# Handouts from NRC - 7 Pages

## PUBLIC MEETING - JULY 11, 2005 NFPA 805 REGULATORY GUIDE ACRS COMMENTS

ACRS COMMENTS (Ref. June 14, 2005 letter; ML051650432)

Public Meeting - July 11, 2005  
NFPA 805 Regulatory Guide  
Handouts from NEI - 5 Pages  
Consistency with RG 1.174

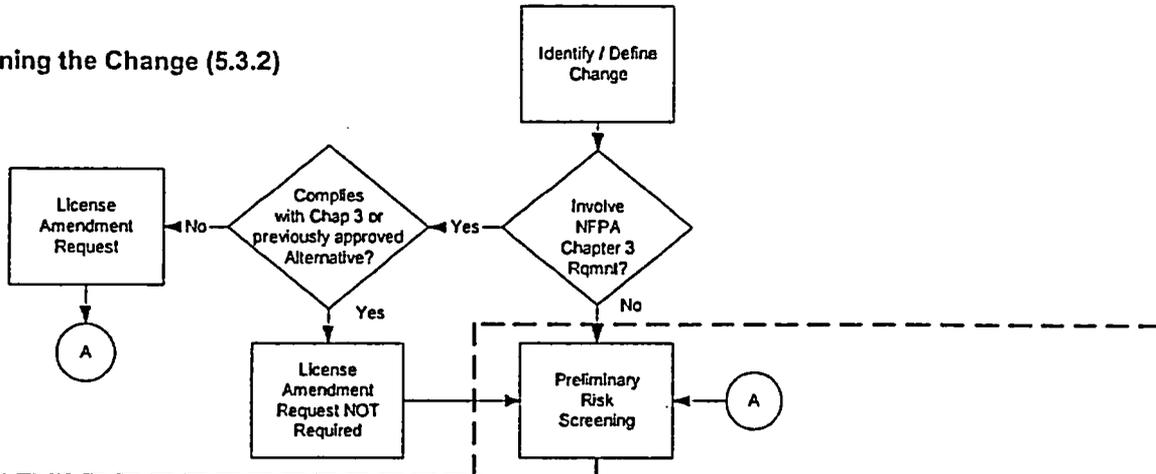
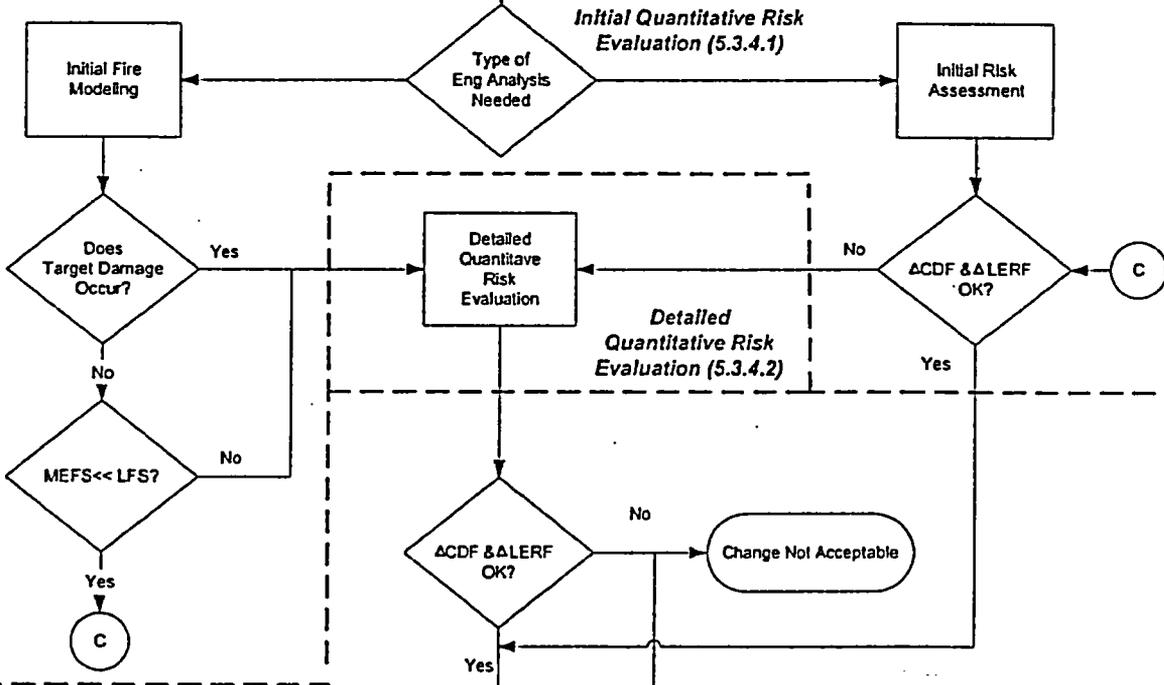
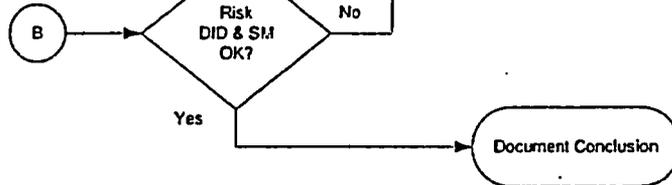
**Status:** Risk assessment is already required by NEI 04-02 Fig 5-1, however the text of NEI 04-02 notes that if it can be demonstrated by fire modeling that the SSD path is free of fire damage, no further risk assessment is required (Section 5.3.4.1, etc).

4. Section 5.3.1, first of 2 bullets at bottom of page 42: change "approved by the AHJ" to "accepted by the AHJ"
5. Figure 5-1: Discuss proposed Staff changes and agree on final configuration.

1. The "initial fire modeling" approach should not be used as an alternative to estimates of changes in core damage frequency ( $\Delta CDF$ ) and large early release frequency ( $\Delta LERF$ ). Identification of a success path does not necessarily assure that  $\Delta CDF$  and  $\Delta LERF$  are negligible (Section 5.3.4.1 of NEI 04-02).
2. The definitions of MEFS and LFS in NFPA 805 and NEI 04-02 are sometimes confusing and contradictory.

1. Proposed edits to Section 5.3.4.1 of NEI 04-02
  - Modify Figure 5-1 to indicate that initial fire modeling requires a  $\Delta CDF / \Delta LERF$  assessment. See attached.
  - Modify Section 5.3.4.1. Divide into 3 subsections:
    - 5.3.4 Quantitative Risk Evaluation
      - 5.3.4.1 Initial Quantitative Risk Evaluation
        - 5.3.4.1.1 Initial Fire Modeling Assessment
        - 5.3.4.1.2 Initial Risk Assessment
        - 5.3.4.1.3 Acceptability Determination for Initial Quantitative Risk Evaluation
      - 5.3.4.2 Detailed Quantitative Risk Evaluation
